## **SB, Rider ProFlex 21, Repair kit for engine hood, 2001-06**

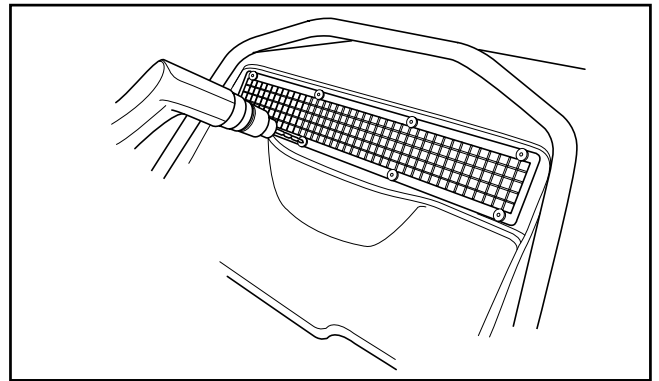
In certain situations it can happen that the fan grille on the engine can come in contact with the engine hood, which results in damage to the engine hood.

In order to rectify this problem a repair kit has been developed. The kit is now in stock and can be ordered by quoting part number 535 41 76-01.

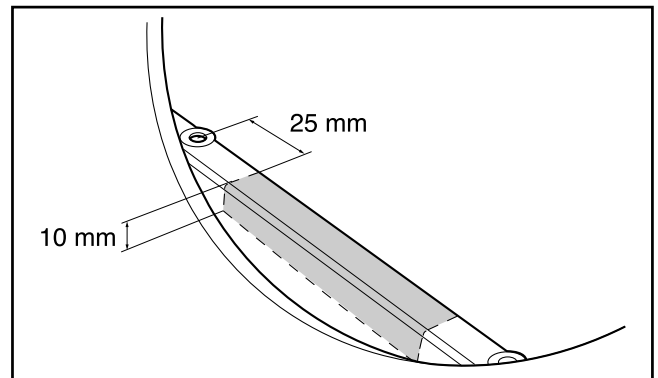
1. Drill out the pop rivets and remove the grille.

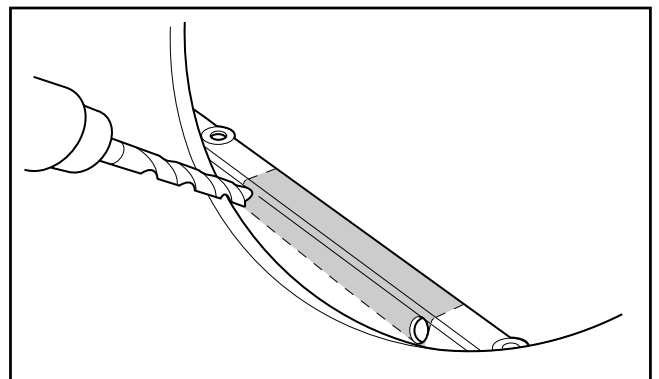
2. Measure and mark out the section to be removed.

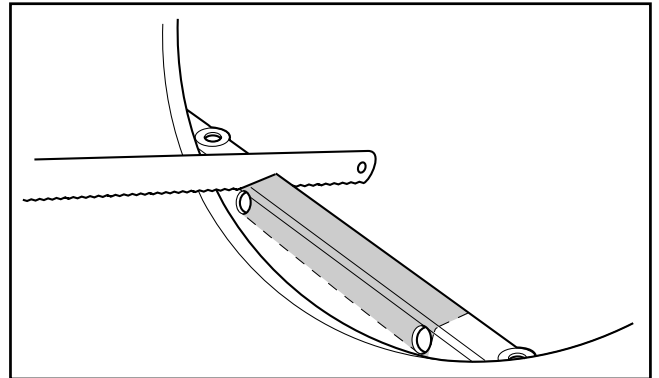
4. Cut out along the marks.

5. Rivet the grille back in place together with the enclosed cover.
